City of Alexandria, Virginia

MEMORANDUM

SUBJECT: CONCEPT REVIEW OF 900 WOLFE, 450 SOUTH PATRICK, 431 SOUTH
COLUMBUS STREETS: HERITAGE AT OLD TOWN
BAR CASE # 2020-00196

Figure 1: Proposed building heights

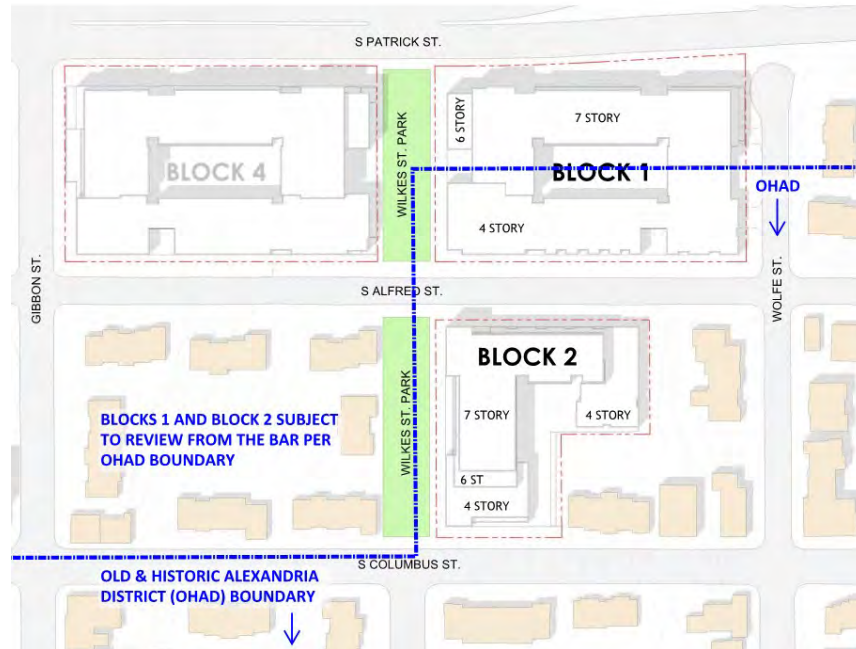
The South Patrick Street Housing Affordability Strategy establishes height limits for each of the blocks. For Block 1, the height limit ranges from 45’-55’ and for Block 2 the height limit range is 45’-62’ (maximum based on the height of the existing mid-rise multifamily building). In addition, the applicant proposes to utilize bonus height and density for the provision of affordable housing per Section 7-700, allowing an increase in height up to 25’ where a height greater than 50’ is permitted. As part of the Development Special Use Permit (DSUP) request, the applicant is working with City staff to propose amendments to the Strategy to shift height to achieve more compatible massing overall and create a better building design more responsive to the context.

Staff finds the proposed new construction to be appropriate to the scale and transitional character of this diverse section of the historic district which includes a range of building typologies, massing, scale, and architectural styles. Particularly appropriate is the transition of the massing of the buildings from the taller portions adjacent to the edge of the historic district to the more townhouse scale elements on the north and east portions of each building. Staff has met with the applicant several times and provided feedback which has resulted in an improved proposal. The applicant has proposed a more contemporary style that utilizes established proportions and rhythm, balanced building compositions, and high-quality materials to create an appropriate and compatible design as opposed to incorporating historicist elements which would be awkward and unsuccessful. Areas of buildings with greater height are sensitively located away from lower-scale historic buildings. Initial designs included overly complex building elevations with an almost chaotic variety of building forms and fenestration patterns. The designs as currently proposed result in more cohesive buildings with a recognizable formal hierarchy and transition from taller to shorter portions of the building. When reviewing this project, it is helpful to look at each individual building as it relates to its adjacent neighbors while also keeping in mind that these buildings should be compatible with one another, still allowing for individuality.

Figure 8: Small area plan pedestrian access

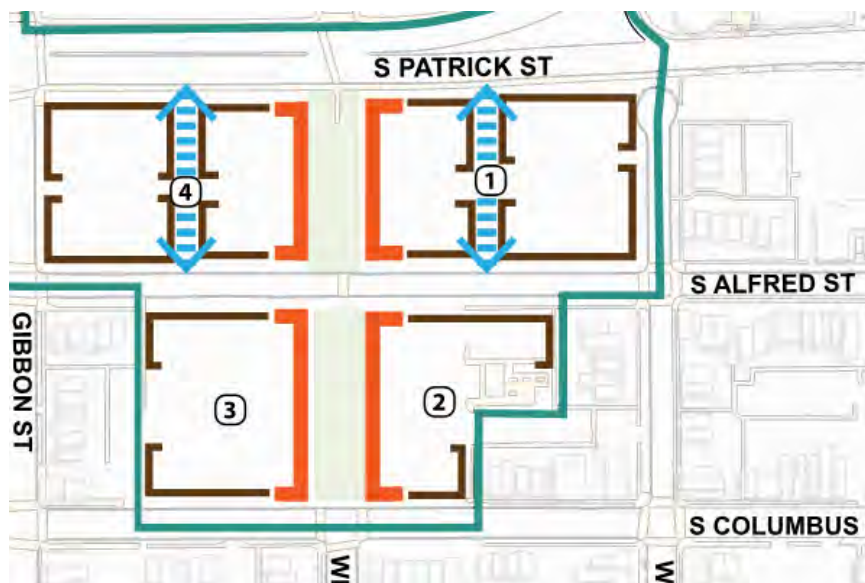
As noted above, the Design Guidelines states that “new construction must conform to the requirements of the applicable small area plan chapter of the Master Plan”. Section 3.16 of the South Patrick Street Housing Affordability Recommendations states that “Mid-block pedestrian connections should be applied, as depicted in Figure 3.9, to avoid long building spans while providing pedestrian circulation through sites” (**Figure 8**).

Full block building developments can disrupt the rhythm of solids and voids found in blocks throughout the historic district. This rhythm creates a dynamic block face as structures are set back from the sidewalk in varying dimensions and a combination of attached and detached structures allow for views into the interior of the block. This porosity is critical to the richness of the urban environment.

Because Wolfe Street does not go through to South Patrick Street, pedestrian access to the neighborhood east of South Patrick Street is restricted to either the Wilkes Street Park or Duke Street. A continuous, unbroken streetscape like this is unusual in Old Town and serves to further cut off this neighborhood from South Patrick Street and streets to the west.

In order to remedy these issues, the applicant should consider the introduction of a mid-block pedestrian break through the proposed development. Located where the current design has a break in the building would help to reinforce the *parti* of the design as a separate northern block, eastern block, and western wing. As currently designed, there is a two-story break on the west side and a one-story break on the east side. This allows for a limited view corridor but does not resolve the issue of the long unbroken building face. Revising this into a full height break in the building with through pedestrian access would create a porosity similar to blocks throughout the historic district.

1 BLOCK 1 - NW CORNER - WOLFE ST. & S. PATRICK ST.

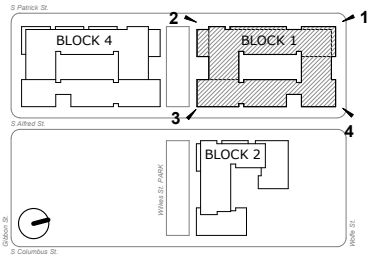
The seven-story recessed massing at the northwest corner is flat and without any perceived detail (**Figure 3**). This part of the building extends to the ground on the north elevation. As proposed, the material for this section appears to be metal or some other smooth cladding. The applicant should consider using a masonry material in this location to provide a visual weight and level of detail to the massing. The windows at this location are located flush or slightly recessed from the face of the exterior skin. Switching the exterior to masonry and recessing the windows will add depth to the exterior elevation. The Juliette balconies are shown flat against the face of the building, this is a design feature that is more commonly seen on suburban residential buildings and is not encouraged in this urban context. In lieu of these, more pronounced balconies with projecting and recessed components should be included. The applicant should consider revising the design of this important corner of the building to be a more clearly articulated building with depth and texture to complement the projecting bays.

The projecting bay at the northwest corner features a masonry band at the fourth-floor line. Along with the recessed balconies, this decorative element helps to reduce the scale of the building and adds a texture to the elevation that is lacking in other parts of the building. Staff supports this approach and encourages the applicant to explore other potential areas for this kind of articulation.

4 BLOCK 1 - NE CORNER - S. ALFRED ST. & WOLFE ST.

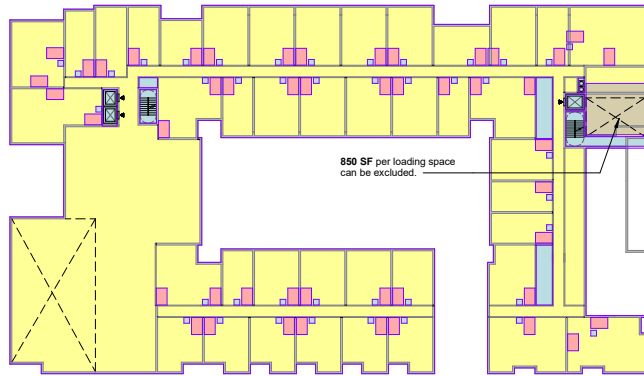
The townhouse elements along the east elevation of the building successfully address the streetscape in a rhythm similar to the surrounding historic neighborhood. The massing at the northeast corner uses the same language as the townhouse elements but because of the entrance to the garage and the adjacent building entrances the scale is not as successful as the other part along South Alfred Street (**Figure 6**). The applicant should revise this massing so that the northeast corner of the building reads as an independent element that is similar to, but shorter than, the massing at the northwest corner. In addition to resolving the issue of scale, this will create a strong anchor point at the north end of the east elevation to counter the tower element at the southeast corner.
